Dunedin Tunnels Trail Project Risk Register

PROJECT:
DUNEDIN TUNNELS TRAIL

ViaStrada has been commissioned by Dunedin City Council to conduct a second concept design stage road safety audit of the ammended alignment of the Twin Tunnels Trail between Mosgiel and Caversham.

Figure 1-1: Twin Tunnels Trail - Option E route

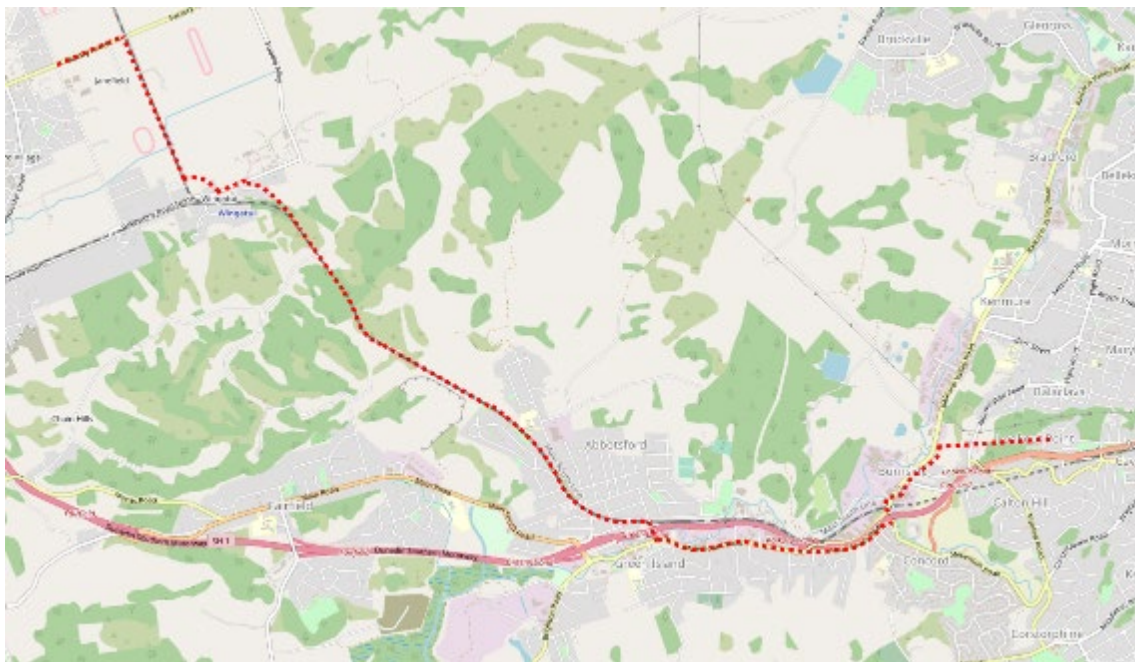
Several options have previously been developed for the route, with Option E selected for the initial audit. This option included a section of bi-directional shared use path through Green Island along the side of Main South Road as shown in Figure 1-1.

Figure 2-1: short sharp curves to avoid rail hardware

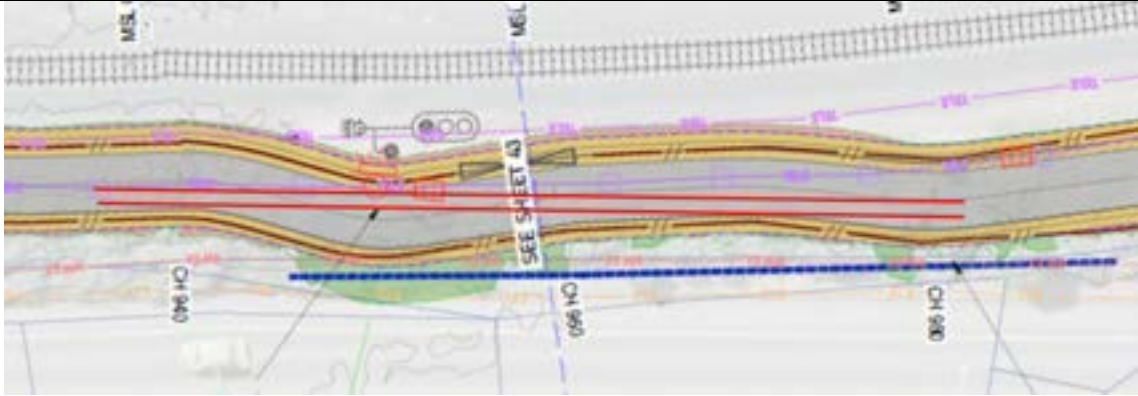
2.1.1. Shared path width constraints & in-path hazards	Minor
- Crashes are likely to be: Infrequent - Death or serious injury is: Unlikely - Risk ranking: Minor	
Utility poles and services, driveway ramps and rubbish bins reduce the available width of the shared path. It is important for the shared path to be user-friendly and perceived as such. Providing a suitable width, clear path of travel will help to achieve this. There is an example at CH 940 – 990 where the path alignment is deviated past some KiwiRail hardware with a series of short sharp reverse curves, see Figure 2-1.

The SAT have drawn two parallel red lines in Figure 2-1 showing the direct line or path riders are likely to take through these curves.

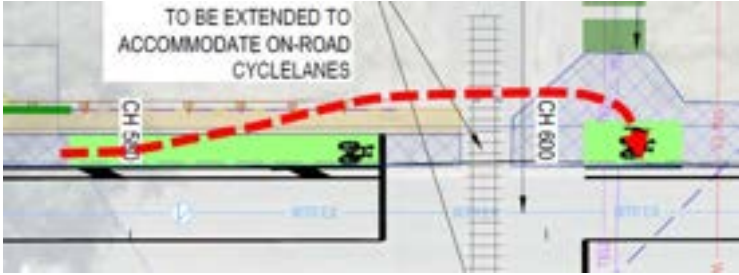
From the west approach (northside) riders can see their destination of the rail corridor and may want to take a diagonal route across Factory Road. This will be easier and more direct than the tight right-angle bend currently provided. An alternate layout is provided in 3.1.4.2 that avoids rail hardware and aligns crossing path user better for crossing the road. This could be supported kerbing and landscape planting.

Cyclists arriving at the intersection from the south or east are not accommodated. As described in general 2.1.3 the path users are likely to make their own route and cut corners to avoid the tight corners. This makes it more difficult for drivers to anticipate where riders will be.

3.1.4.1.	That the designer contact KiwiRail to determine if a LCSIA is required for the Factory Road level crossing.
3.1.4.2.	If a LCSIA is required, then consideration is given to separating the north side path away from the road as shown in Figure 3-3. Any separation between the path and the carriageway at the crossing should be supported by a raised island with landscape planting.  Figure 3-3: northside path option

3.1.4.3.	That the project team considers future proofing this level crossing to accommodate the link to Silverstream.
3.1.4.4.	That better provision is made for cyclists to access the rail corridor path from the east and for riders approaching from the path (south) and turning left into Factory Road.
Designer Response: 3.1.4.1 Agree with SAT recommendation. 3.1.4.2. - 3.1.4.4 SAT proposal will be considered as part of the detailed design development of the rail crossing.	
Safety Engineer: 3.1.4.1. Agree 3.1.4.2. Agree with SAT, cyclists will take the shortest most direct route, especially if they are not going to have to wait to cross the road. Cyclists also need to be guided to cross the rails at 90 degrees to avoid bike wheels slipping between the track and road surface. SAT option may help but there will still be temptation to cross early, even if the buffer is fenced some will choose to travel on the road to avoid slowing down. Consider moving the road crossing point to the Mosgiel side of the railway to eliminate the shortcut. 3.1.4.3. Agree. 3.1.4.4. Agree

Client Decision: Agree with designer response and safety engineer comments, this crossing will be addressed through the detailed design.	
Action Taken: Click here to enter text.

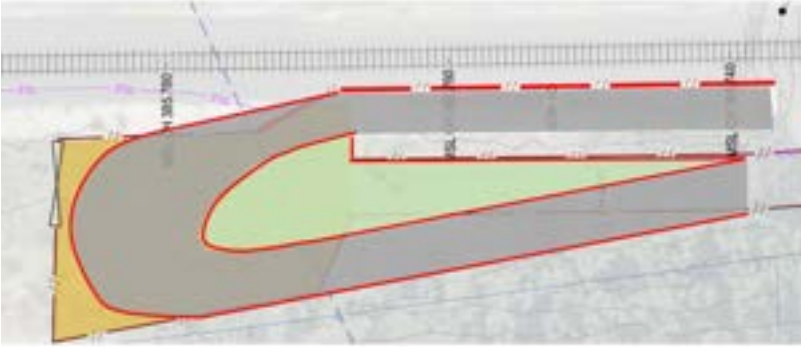
6.1.3. Ramp and turning area	Comment
Sheet 39	
There is a large rectangular area for path users to make the 180 degree turn between the underpass ramp and the path between the state highway and railway line. This will not be intuitive for unfamiliar riders. A slight realignment of the path and a section of fence as shown in Figure 6-3 would allow a more coherent turn.	
Recommendations:

6.1.3.1.	Designer to consider realigning the fence on the south side to provide a more intuitive turning area.  Figure 6-3: concept for ramp and turning area
Designer Response: <i>Agree with SAT recommendation. This will be included in the detailed design of this section once topo survey information is available.</i>	
Safety Engineer: <i>Agree with SAT. The switchback needs to be as wide as possible to allow users to double back. Consider taking the track closer to the motorway to make the turns easier. The new bridge over the culvert may not be required if the track can run alongside the motorway but screening would probably be required.</i>	
Client Decision: <i>Agree with SAT, switchback width will be addressed through detailed design.</i>	
Action Taken: Click here to enter text.
